SUBJECT: MEETING WITH VIRGINIA ELECTRIC AND POWER COMPANY (VEPCO)
AND GENERAL NUCLEAR SYSTEMS, INC. (GNSI)

PURPOSE: To discuss resolution of questions concerning the CASTOR V/21
cask basket originally raised in October 1985 during a
Department of Energy spent fuel storage demonstration using
a CASTOR V/21 cask at the Idaho National Engineering
Laboratory.

COMMENTS ON CASTOR V BASKET ANALYSIS

Test of Basket Welding SN 6

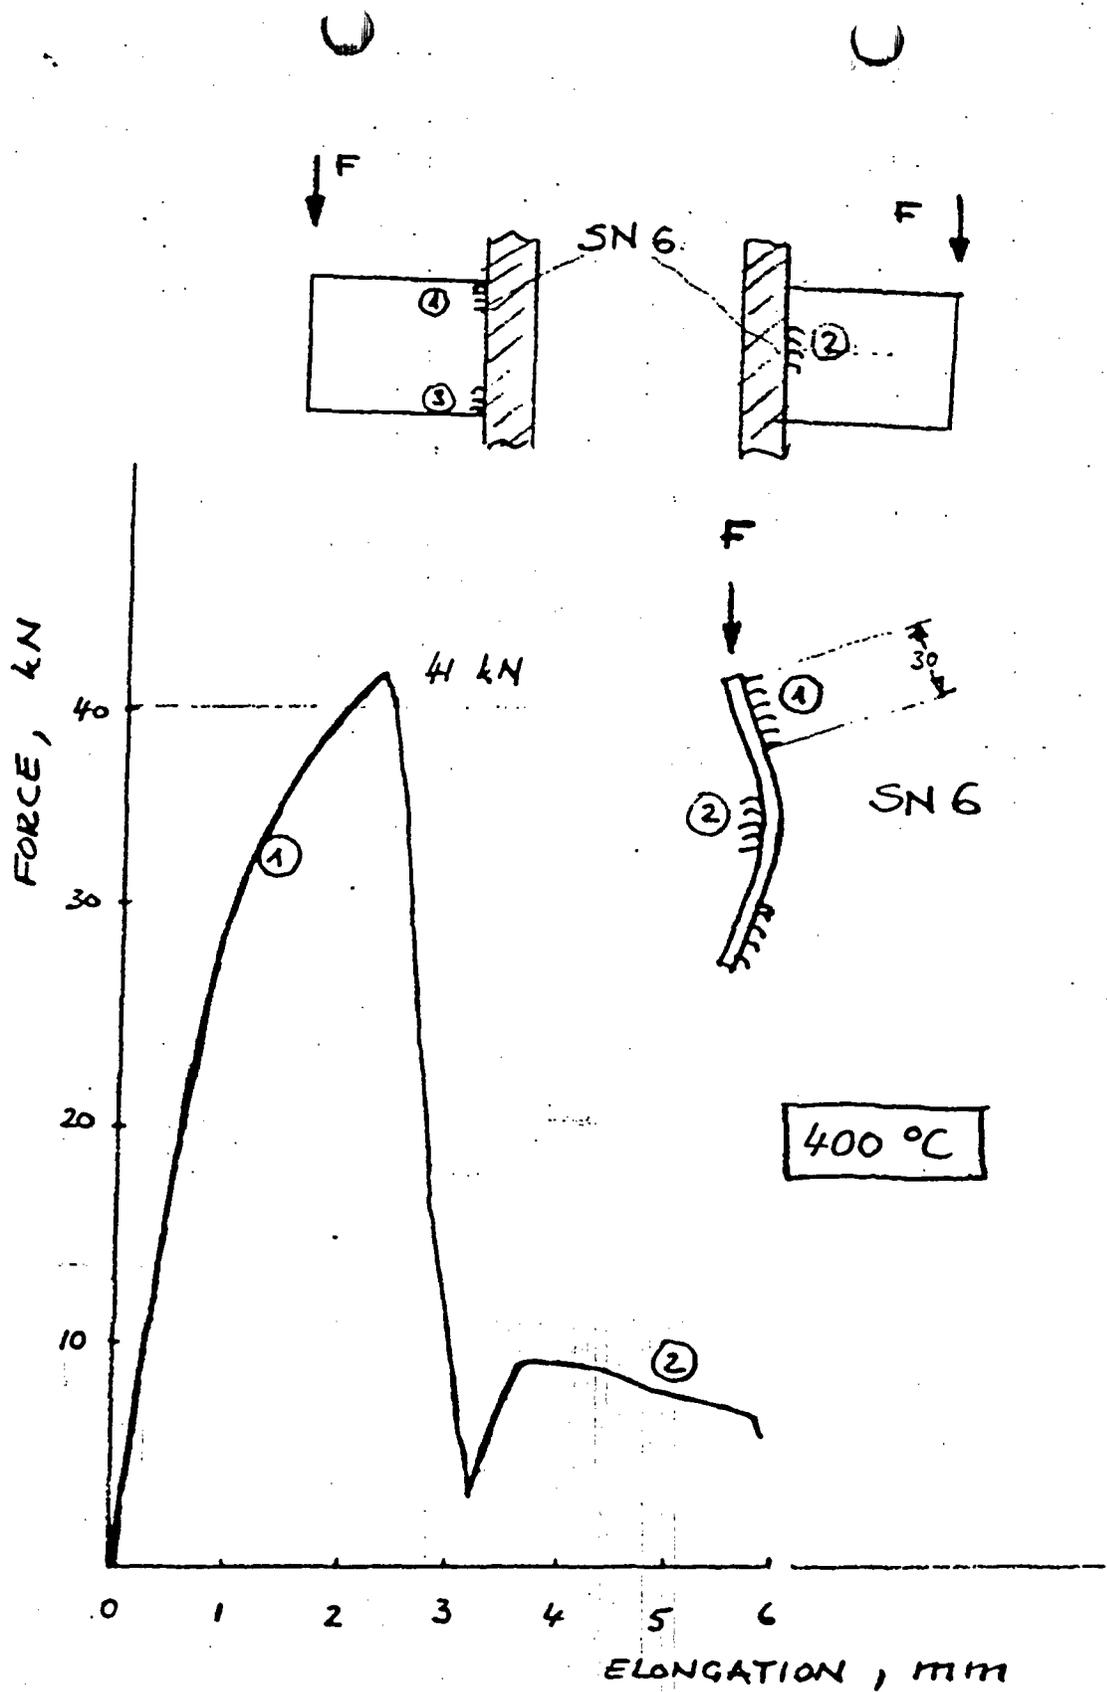
The discussion centered on the first six points of the December 20, 1985, letter to GNSI on the CASTOR V/21 cask basket matter (see enclosure 2). After discussion of these points and of new data that GNSI is obtaining by tests and analyses (see enclosure 3, a figure illustrating one weld test), a set of comments was drawn up to document how the points might be addressed to aid in their resolution. This set of comments was discussed, and a final version of it agreed on before the meeting concluded (see enclosure 4).
